Hannan Knit & Textiles Ltd. (Extension)

21 October 2024

2. Observation

Observation 1: Discrepancy in as-built drawing (Jacquard Shed).

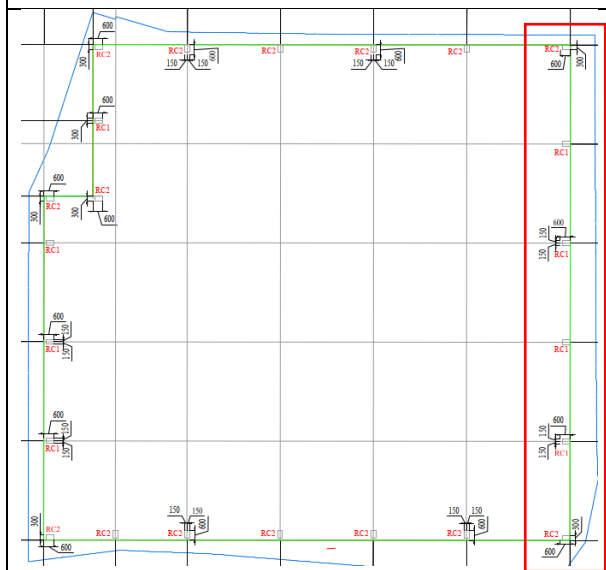
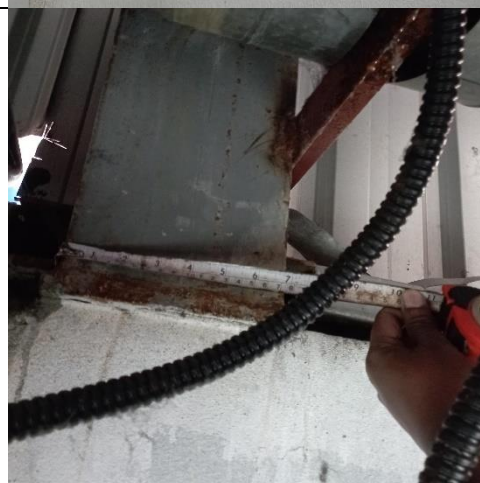
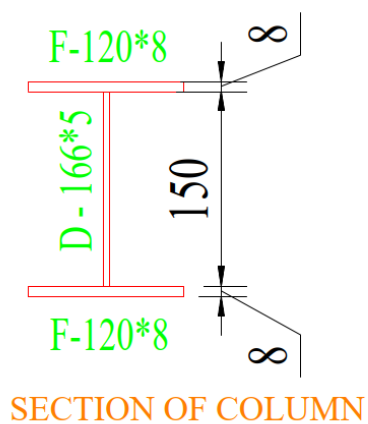
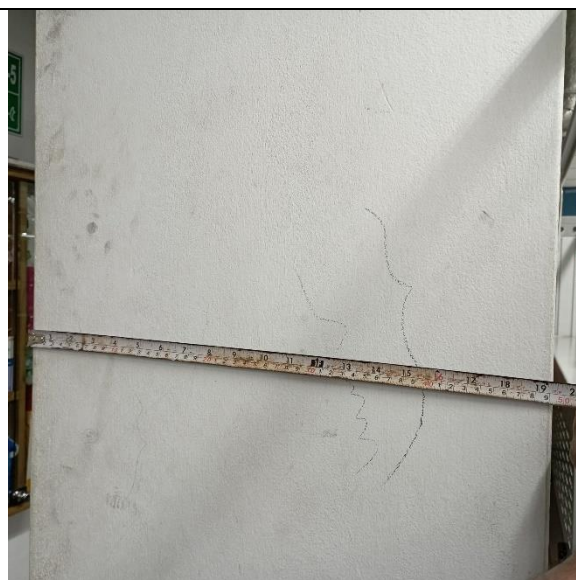
Description: 7 Columns were found instead of 6 columns along grid-7. All RC columns were found 300x 450 instead of 300x600. All steel columns were found F170x W300 instead of F120x W150. The building engineer is required to produce accurate as-built drawings.

Item No.	Observation	Action Plan	Timeline
1.	Discrepancy in as-built drawing (Jacquard Shed).	The building engineer is required to produce accurate as-built drawings.	within 6 weeks

Observation 3: Corrosion on steel members (Jacquard Shed).

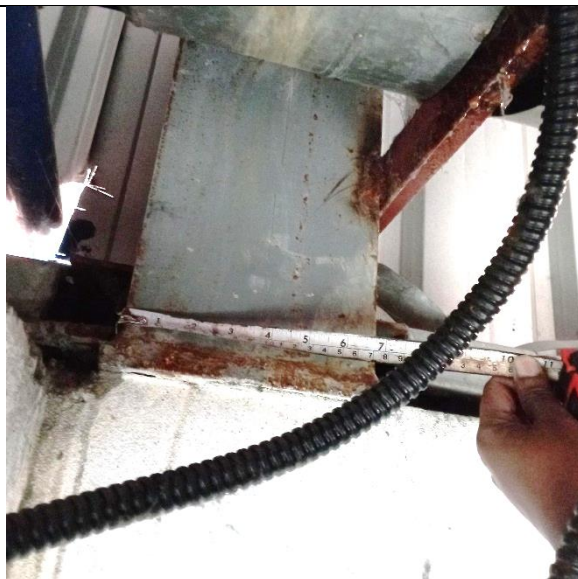
Description: Corrosion was found on steel members at several locations. The building engineer is required to apply rust-proof paint on steel members to prevent corrosion.

Observation 5: Missing information and lack of as-built drawing (Utility Building).

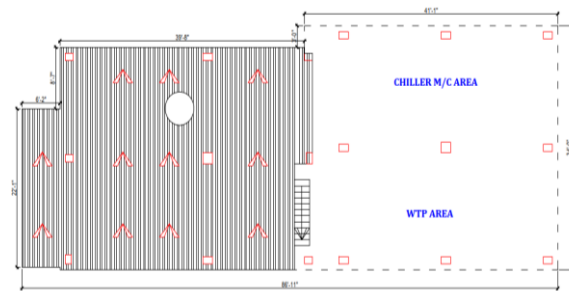
Description: Plastic water tanks (2-2000 liters each) were not shown in the drawings. No structural drawing was available for the shed (east part) and RO plant shed (west part). The building engineer is required to produce an accurate and full set of as-built drawings.

Observation 13: Missing information in as-built drawing (Yarn Storage).

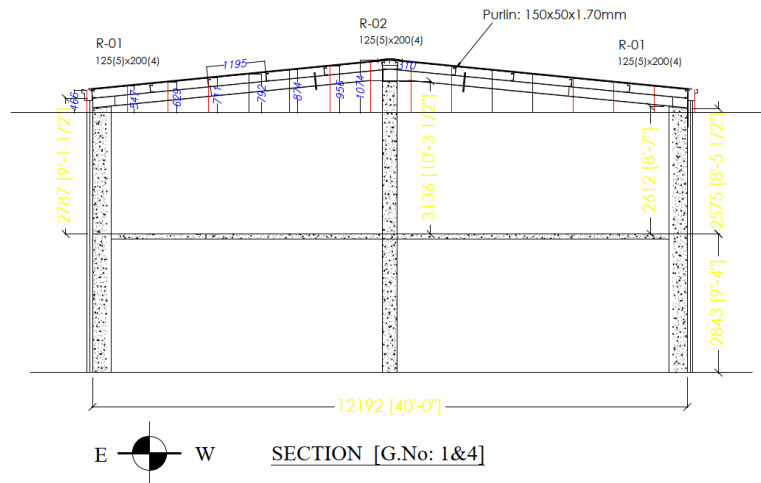
Description: Connection details were not provided as-built drawing. The building engineer is required to produce a full set of as-built drawings.

Observation 15: Lack of lateral Stability of the shed-roof shed (ETP Building).

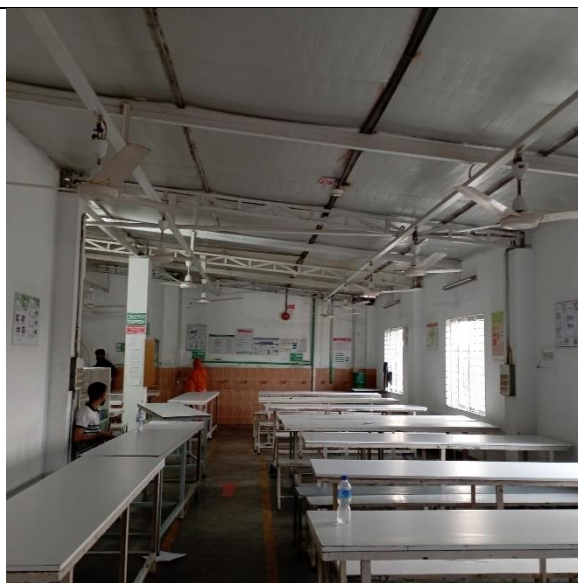
Description: No bracing system (strut, horizontal, and vertical bracing) was found to transmit and resist the lateral load. The building engineer is required to check the lateral stability of the shed and prepare a remediation plan.

Observation 16: Discrepancy in as-built drawing (ETP Building).

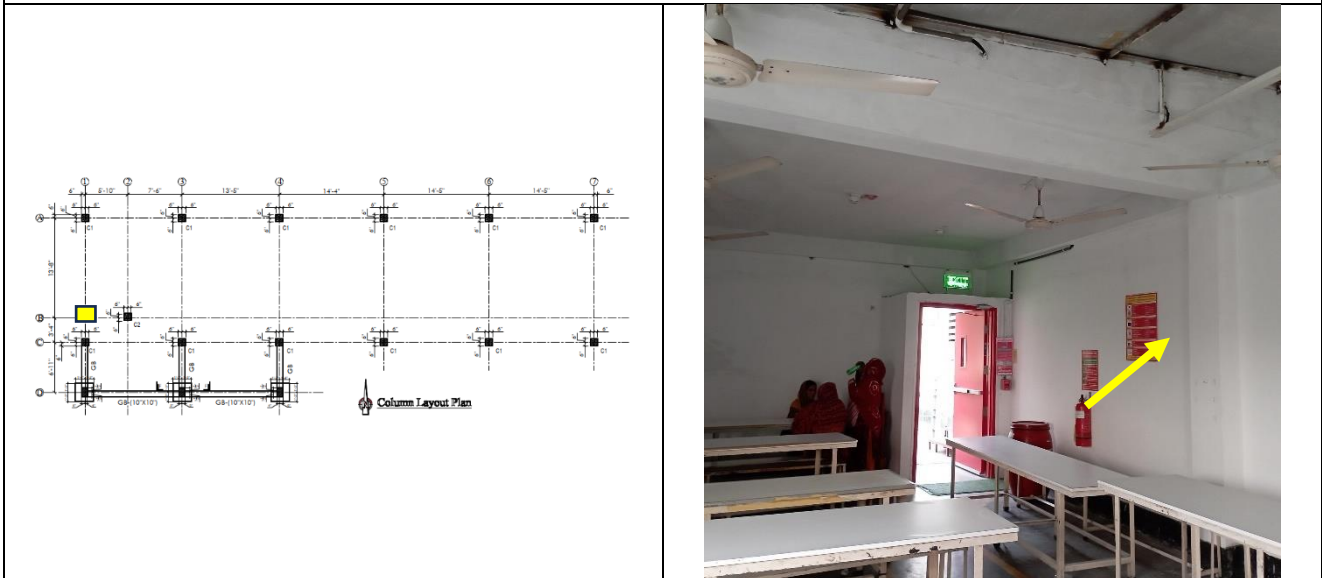
Description: Marked (yellow) column was not shown in column layout. Also, structural drawing of shed was not available. The building engineer is required to produce a full set of accurate as-built drawings.
